MEMORANDUM

Subject: Addendum to MovingAhead Alternatives Analysis Technical Reports

This document is an addendum to the MovingAhead Project's Alternatives Analysis (AA) Draft Final Technical Reports, dated May 2017. This addendum serves to provide new options for mitigating potential adverse effects as related to the information gathered by the AA Technical Reports.

| MovingAhead Concept Plans | | HIGHWAY 99 CORRIDOR EmX ALTERNATIVE Local Mitigation: Patty's | |

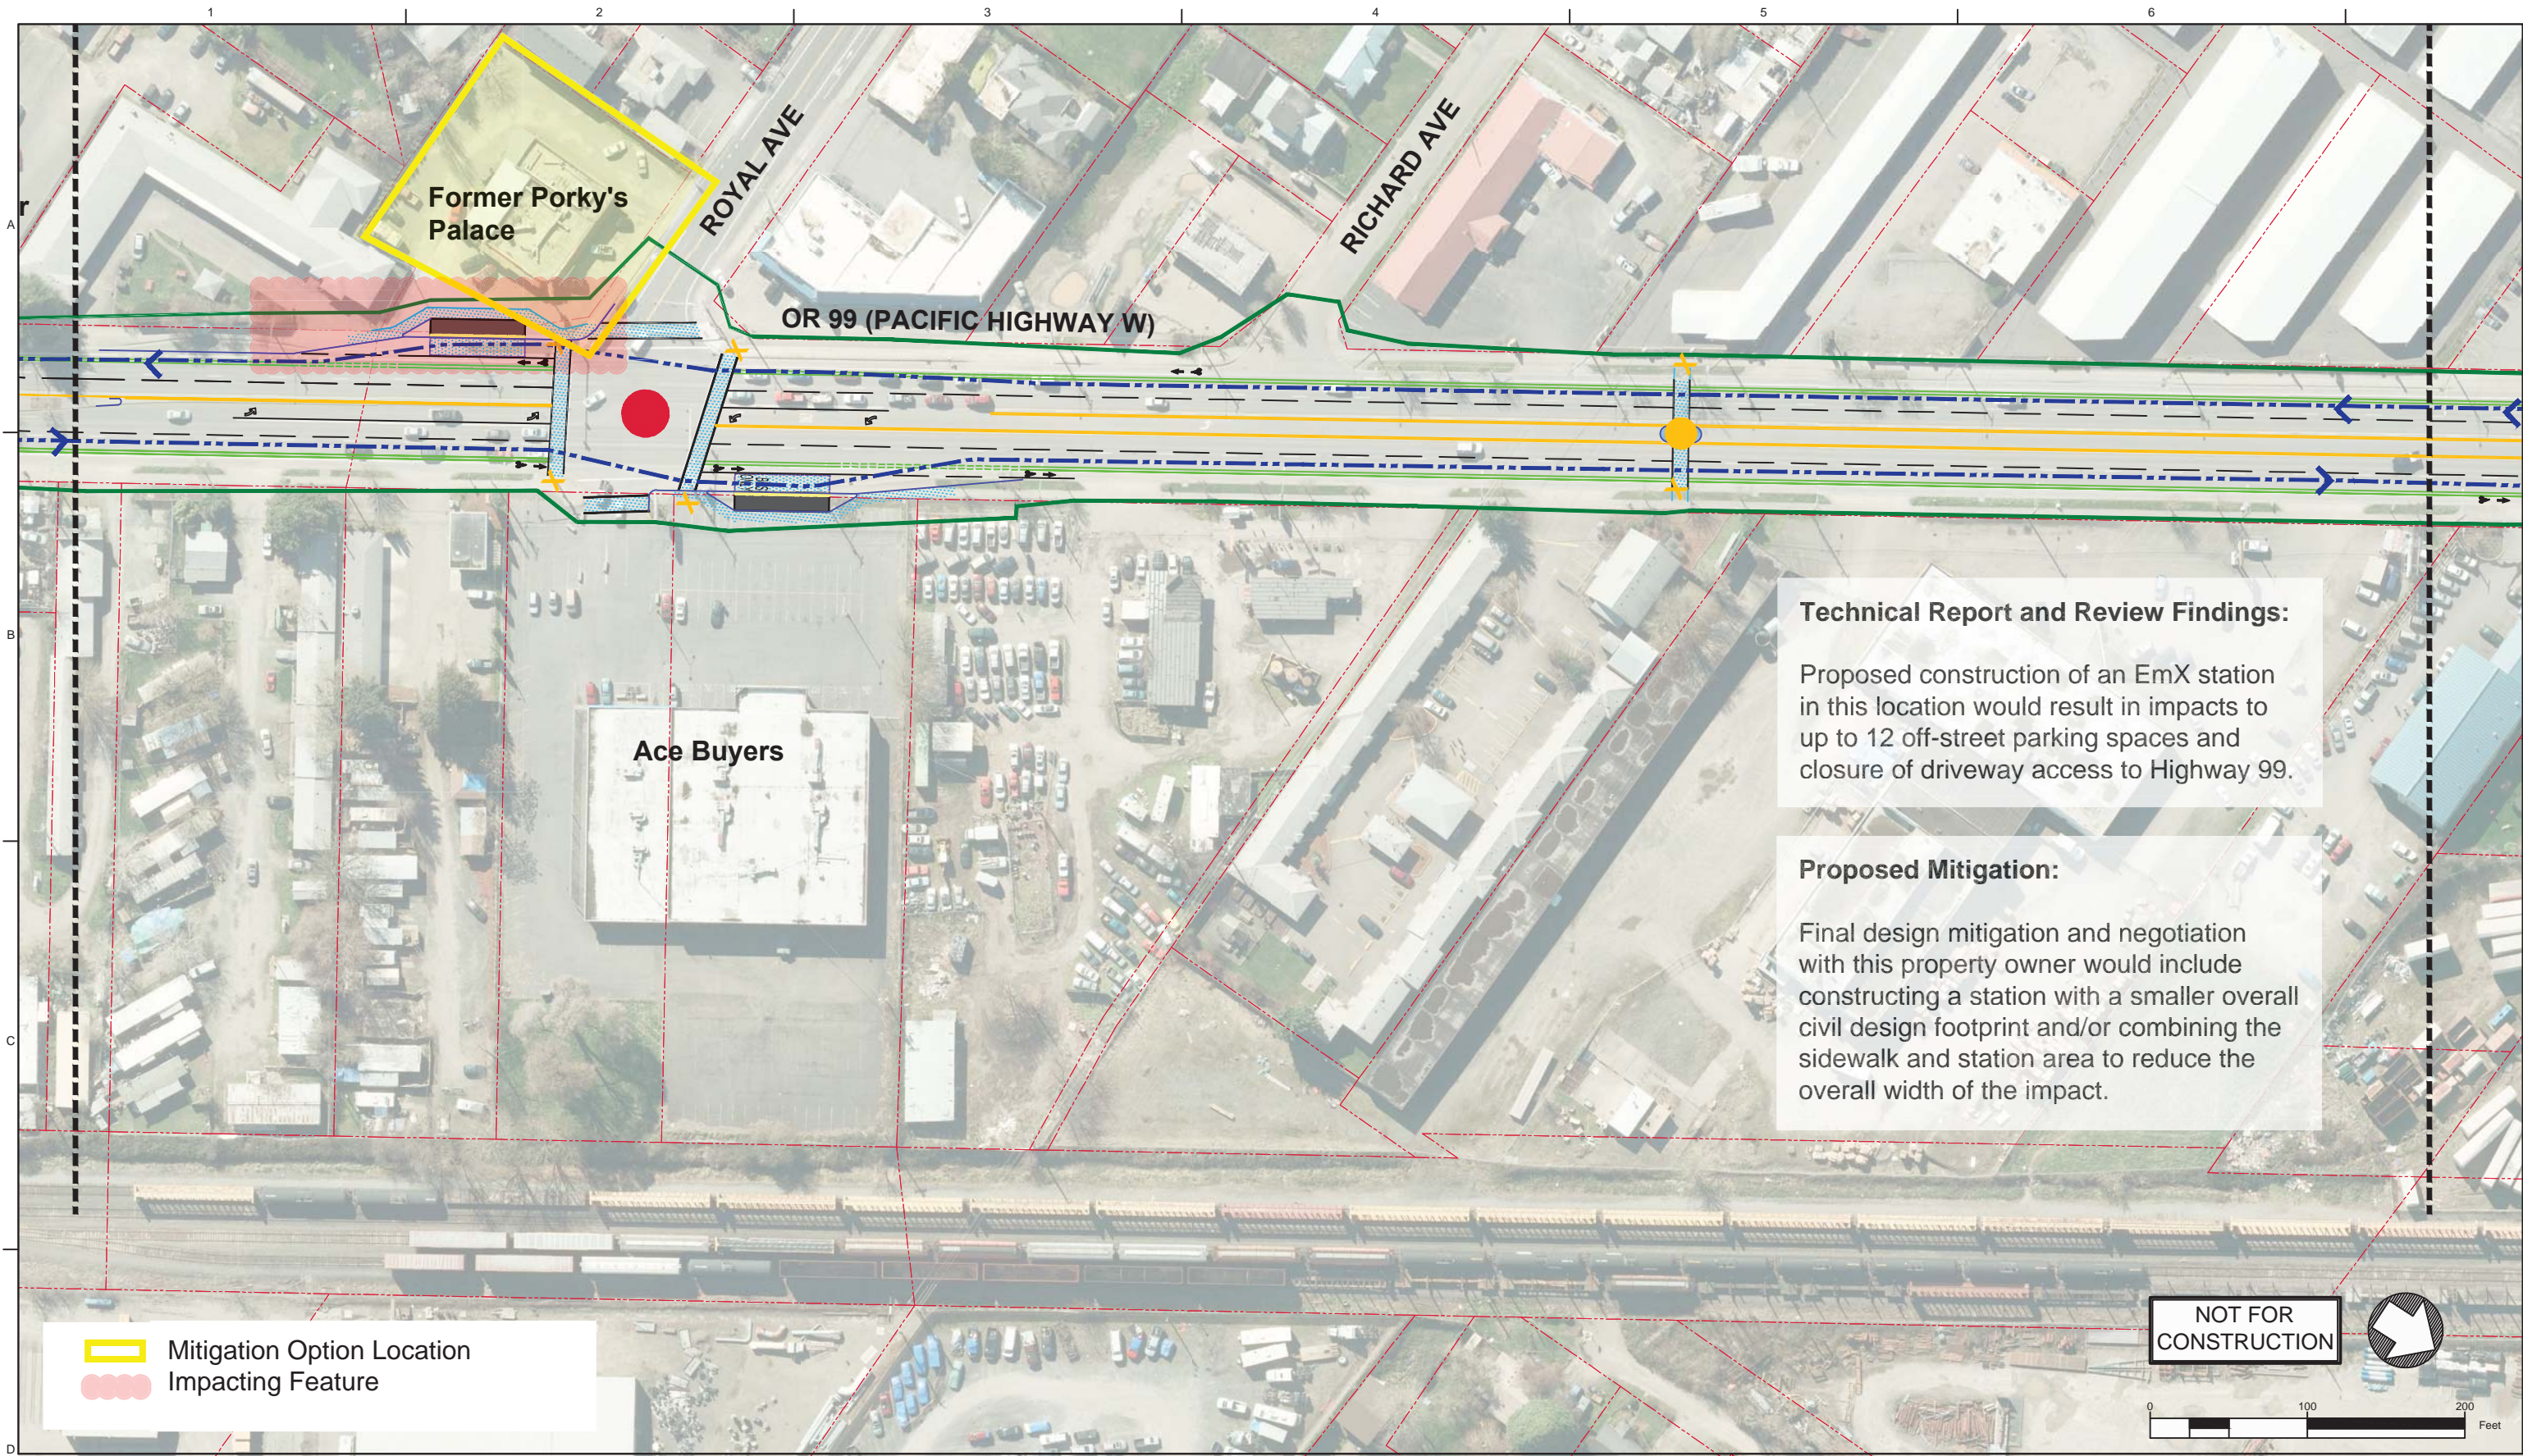
Construction of EmX station and intersection improvements at Roosevelt Boulevard to provide BAT lane and pullout for northbound EmX vehicles would impact approximately two off-street parking spaces.

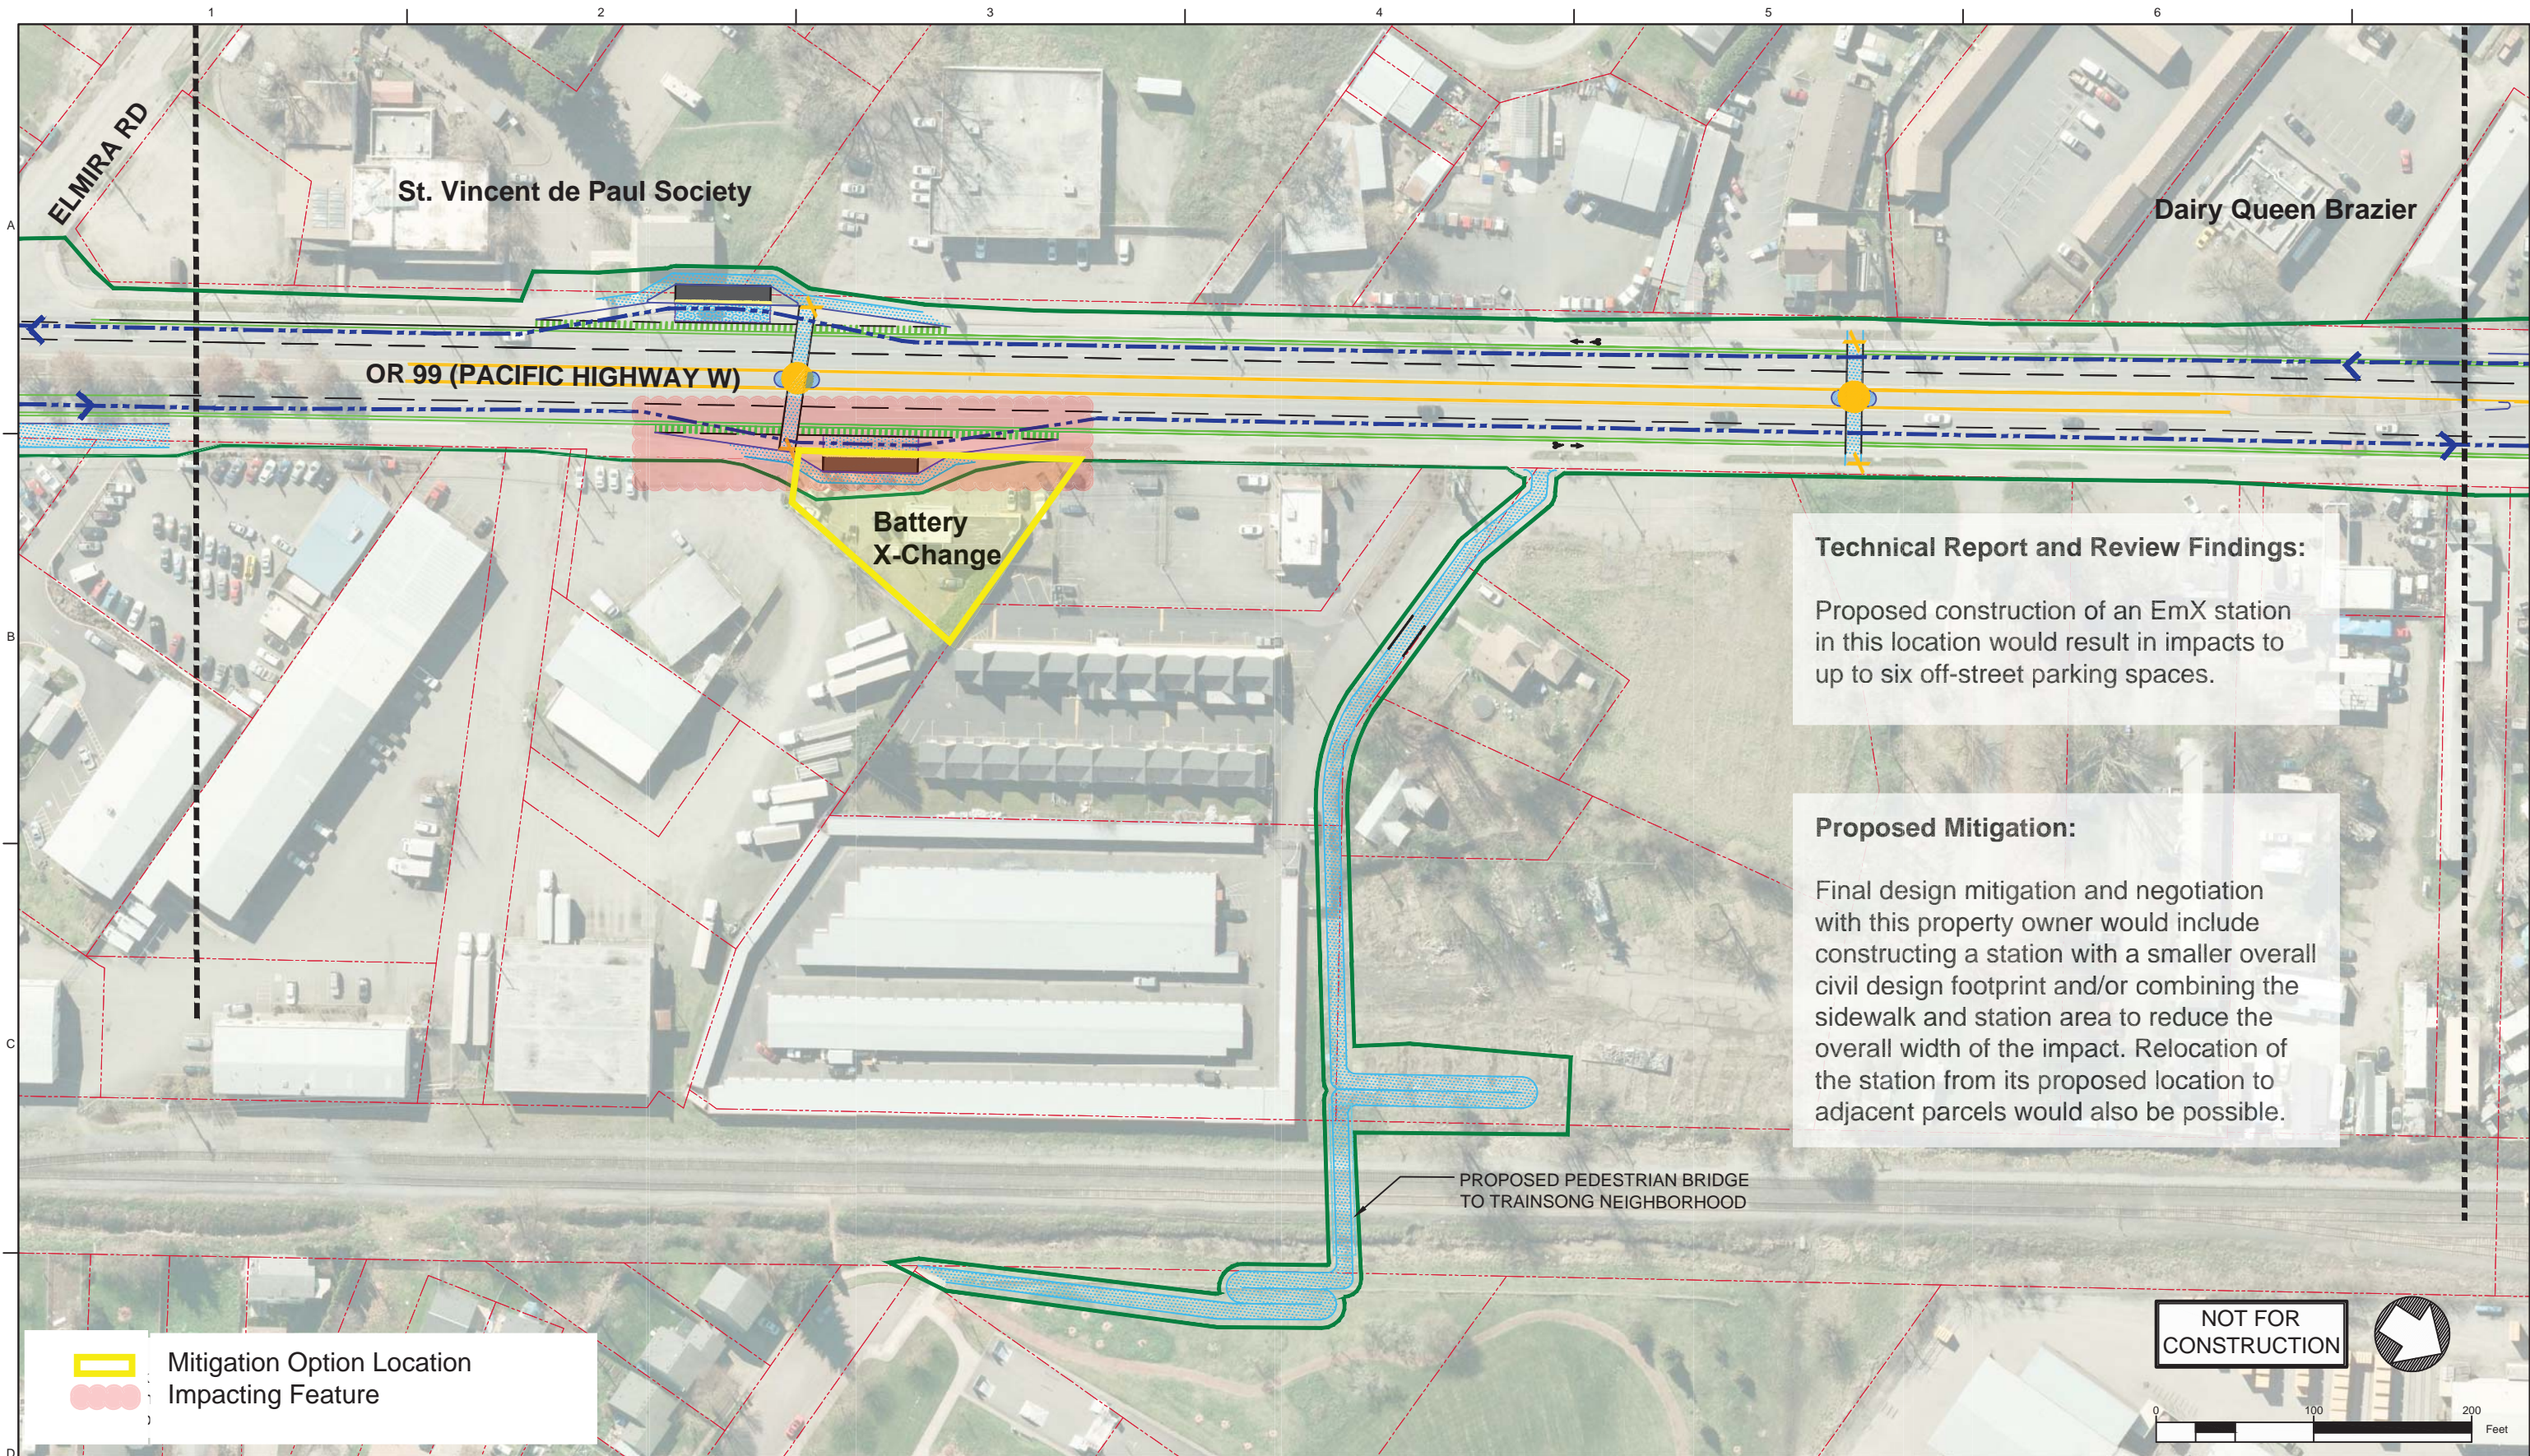
Proposed construction of an EmX station in this location would result in impacts to up to 12 off-street parking spaces and closure of driveway access to Highway 99.

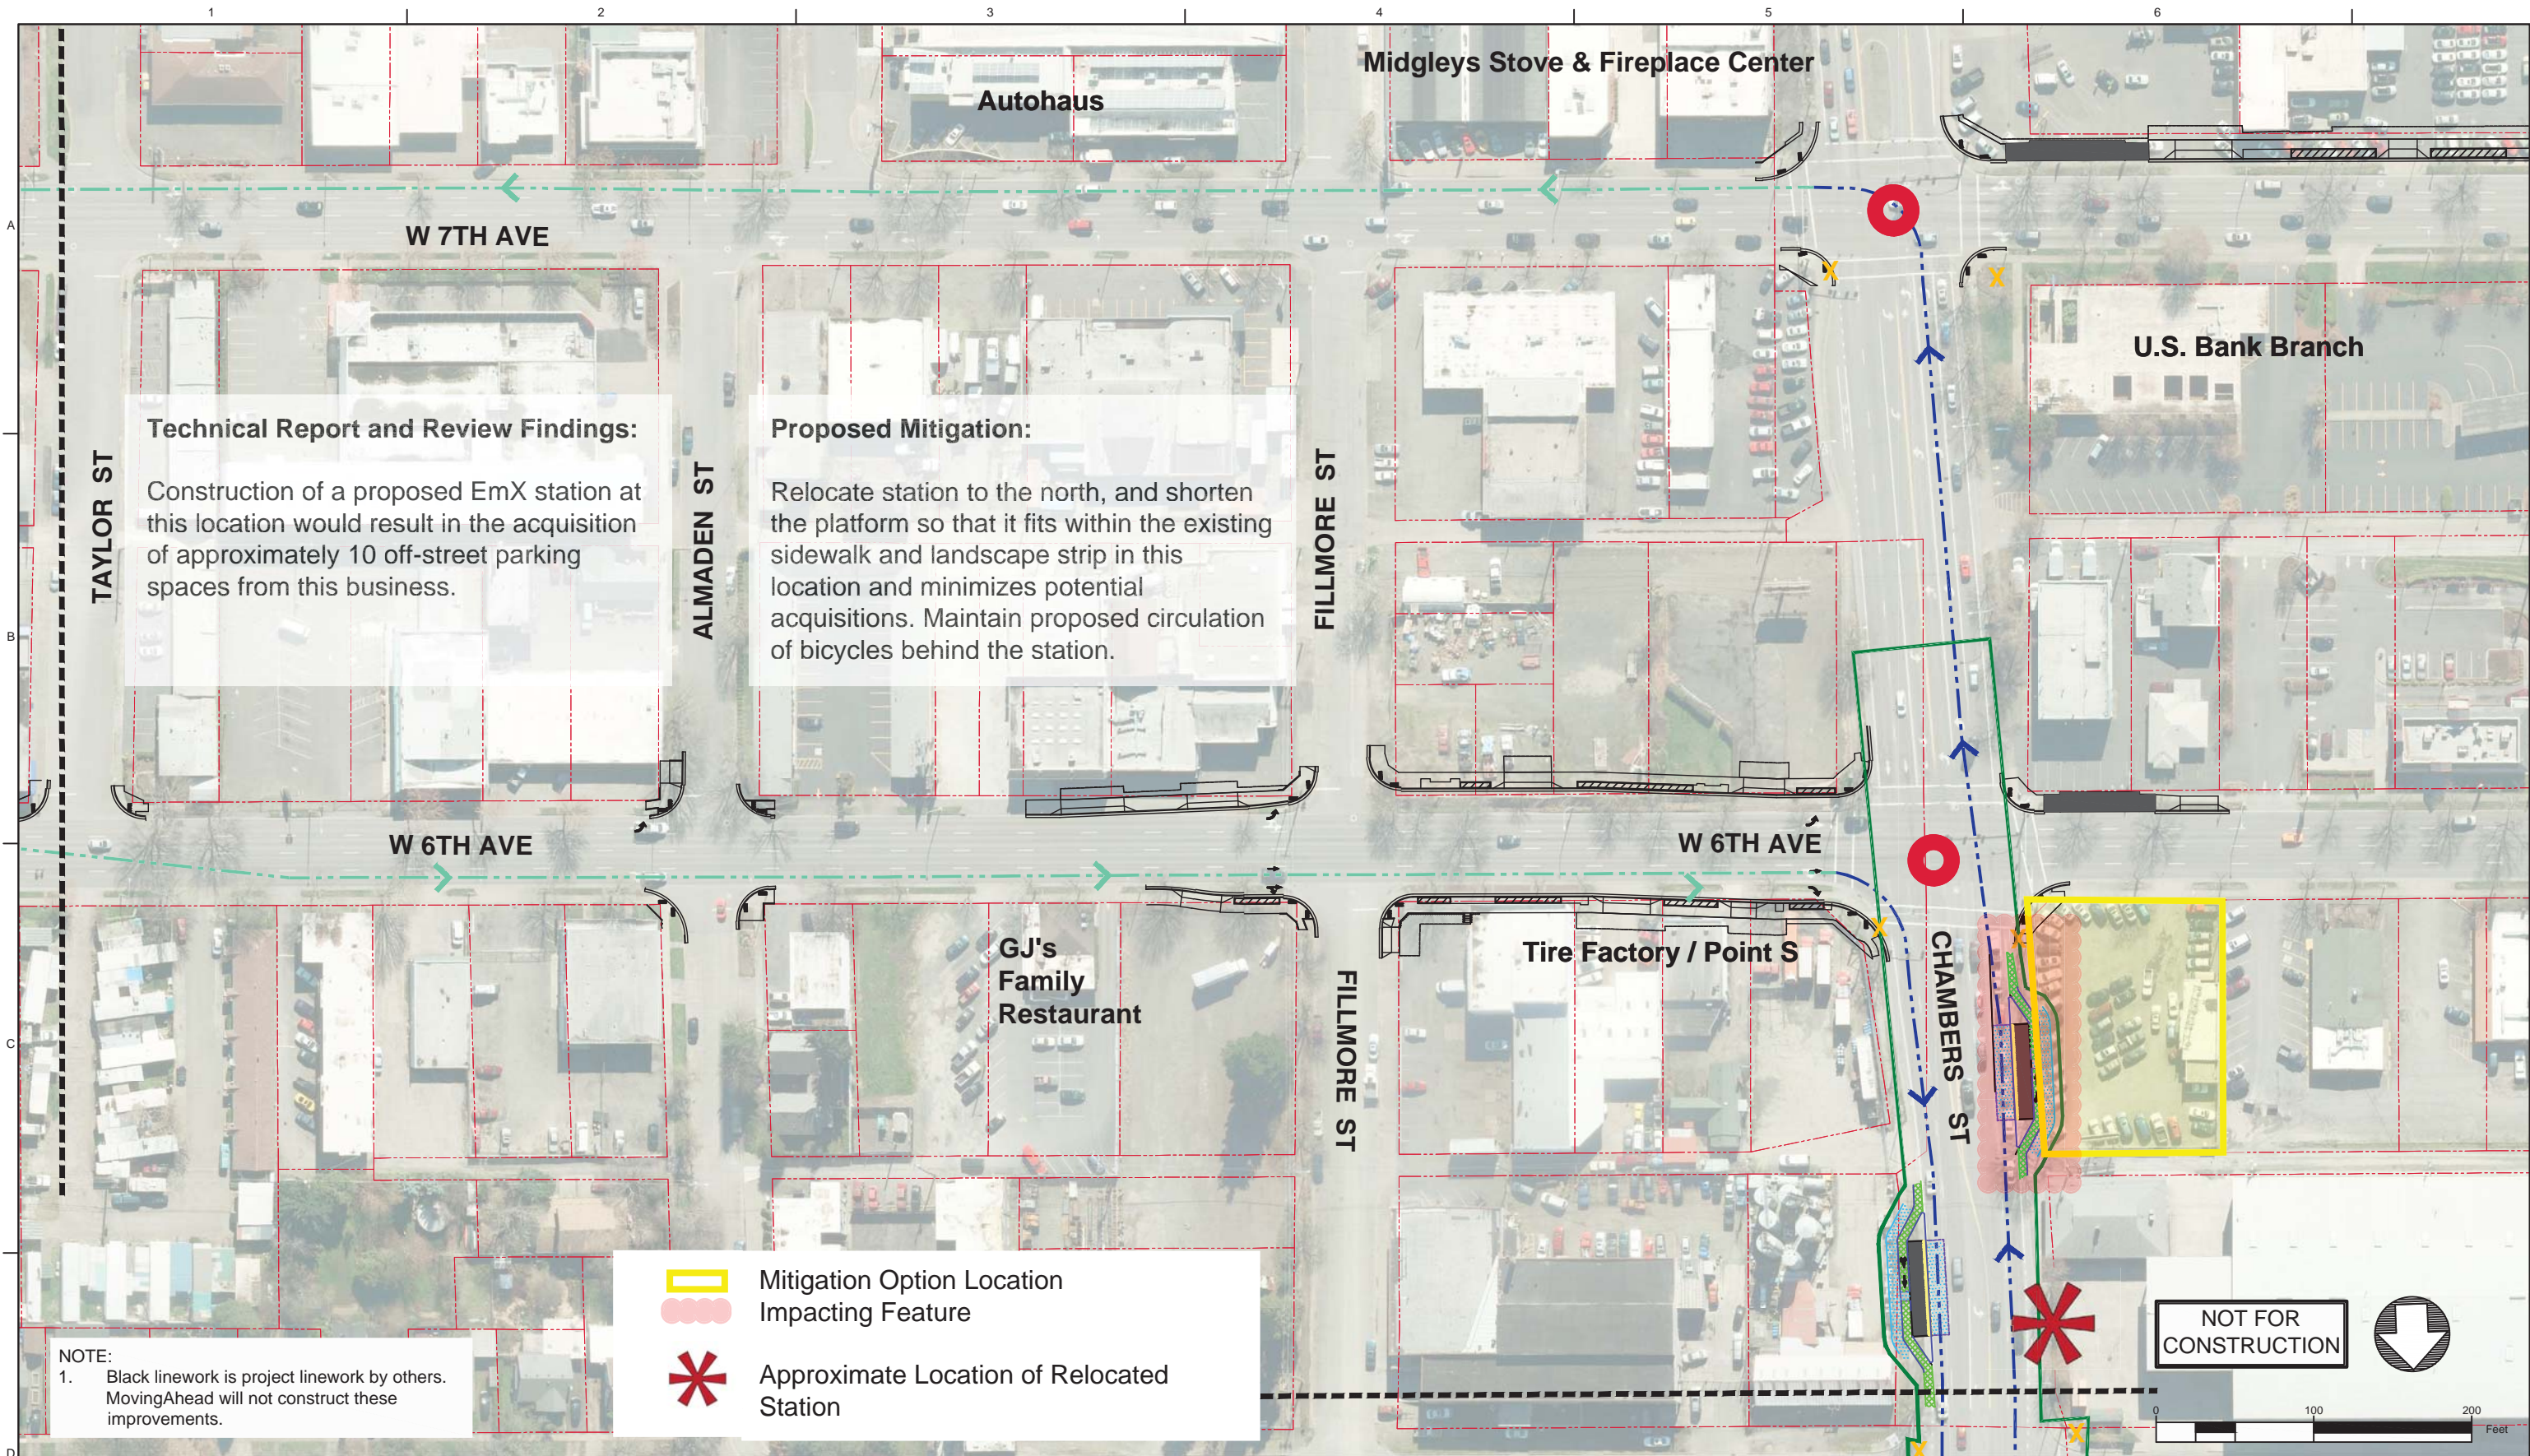
City staff comment on this stop located inside of the Charter Tree boundary of the City indicates that an existing stop location at W. 2nd Avenue and Chambers would better serve land uses, be at grade, and potentially have less risk of impact to trees.
